Groundwater Remedy Phase 2 Construction, PG&E Topock Compressor Station, Needles, California

PG&E TOPOCK GROUNDWATER REMEDIATION PROJECT

Work Variance Request #18 – Incorporation of FW-02B as a freshwater injection well into the groundwater remedy

MONITORING WELL II'
DRILLING LAYOUT

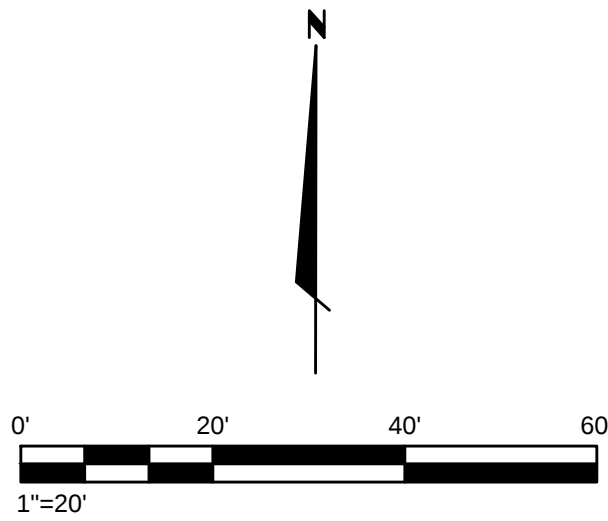
- Install MW-HH and MW-II, with a limited access sonic rig, on existing access roads to minimize overall drilling footprint, as well as disturbance associated with future O&M. Supporting areas (for soil logging, sampling, soil bins staging, etc.) are necessary for drilling. After drilling, these areas will be restored to pre-construction conditions to the extent practicable.

- No well pad is needed for MW-II. A small pad may be required to create a level surface for drilling of MW-HH. The pad, if built, will be removed after construction is complete.
- Reduce the existing pad at FW-02B by approximately 50% (in size) and restore the disturbed area to pre-construction conditions to the extent practicable.
- No permanent expansion of the current footprint of the access road from Bat Cave Wash access road to FW-02B.

TOPOCK GROUNDWATER REMEDIATION PROJECT
BATCAVE WASH-
PLAN AND PROFILE - PIPELINE
"I" STA 10+00 TO STA 16+00
GAS TRANSMISSION & DISTRIBUTION
PACIFIC GAS AND ELECTRIC COMPANY
SAN FRANCISCO, CALIFORNIA

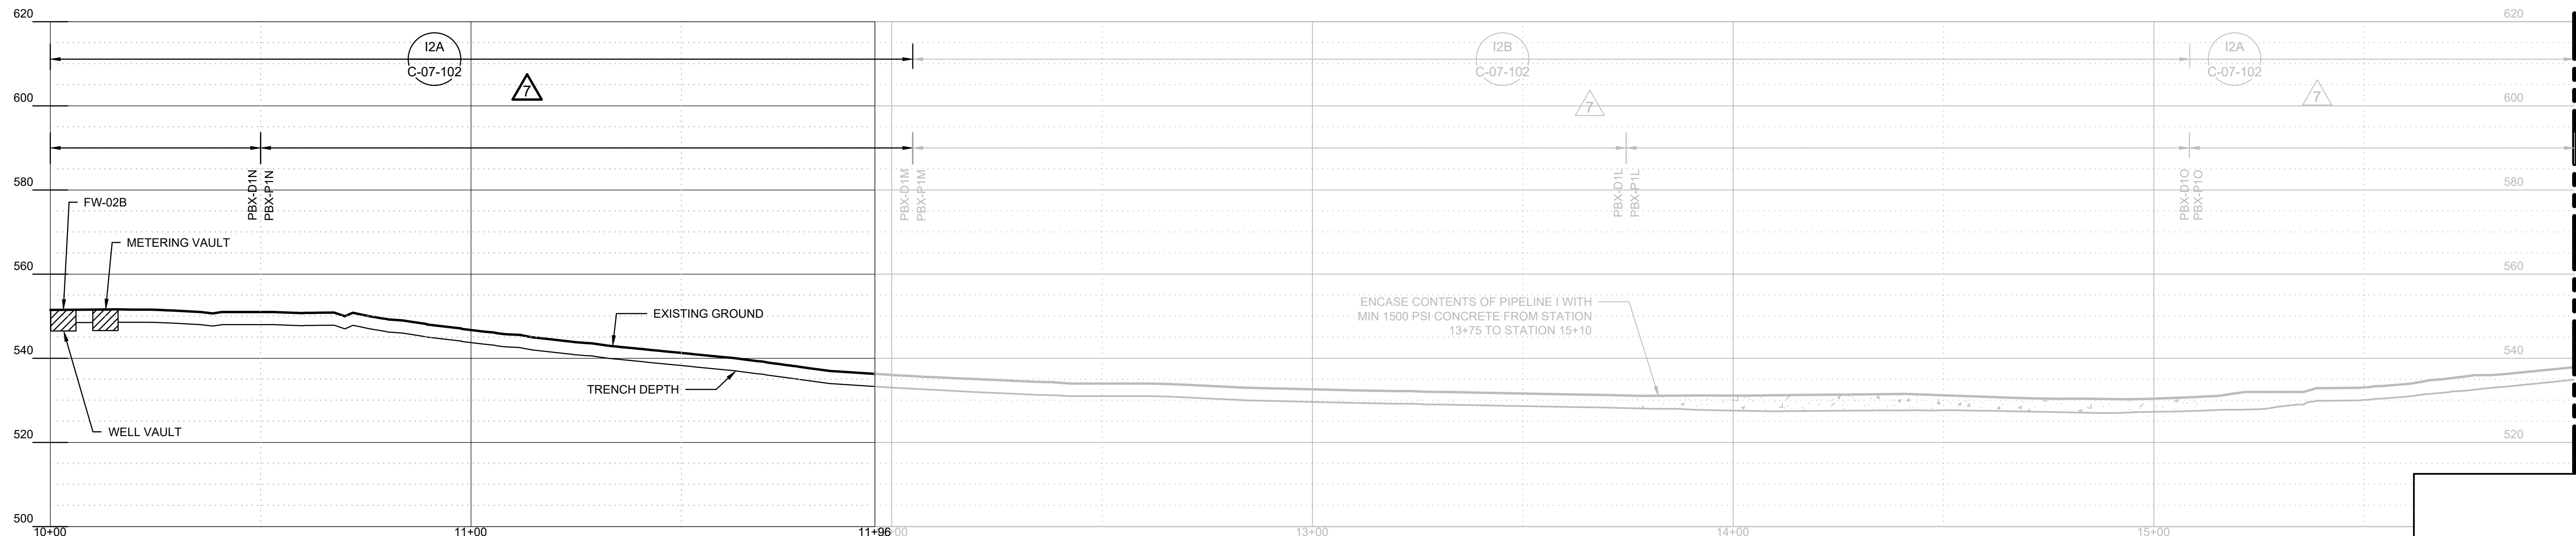
- Well/valve vaults and pull boxes associated with FW-02B.
- Two arsenic monitoring wells MW-HH and MW-II and associated well vaults.
- An extension of Pipeline I (including liquid conveyance pipes and conduits) from Bat Cave Wash access road to FW-02B.
- A new access road to FW-02B from the Bat Cave Wash access road, for use during construction and future operation and maintenance (O&M).
- Erosion control measures to protect constructed infrastructure and minimize disturbance associated with future O&M.

Items	Unit	2015 BOD FW-02Alt as FW injection well	WVR #18 FW-02B as FW injection well	Net Change
Trench length	Linear feet	210	225	+15
Pipe length	Linear feet	840	900*	+60
Electrical conduit length	Linear feet	630	900*	+270
Net Soil Disturbance - Trench, vaults, and pull boxes	Cubic Yard	190 (Cut)	111 (Cut)	-79
Net Soil Disturbance – FW-02 well pad	Cubic Yard	0	4.8 (Cut)	+4.8
New access road	Linear feet	0	150	+150
FW – Freshwater * Includes additional spare conduits and pipes added to Pipeline I trench to allow for future potential uses in BCW. These additional conduits/pipes did not change the size of the trench and fit into the existing trench.
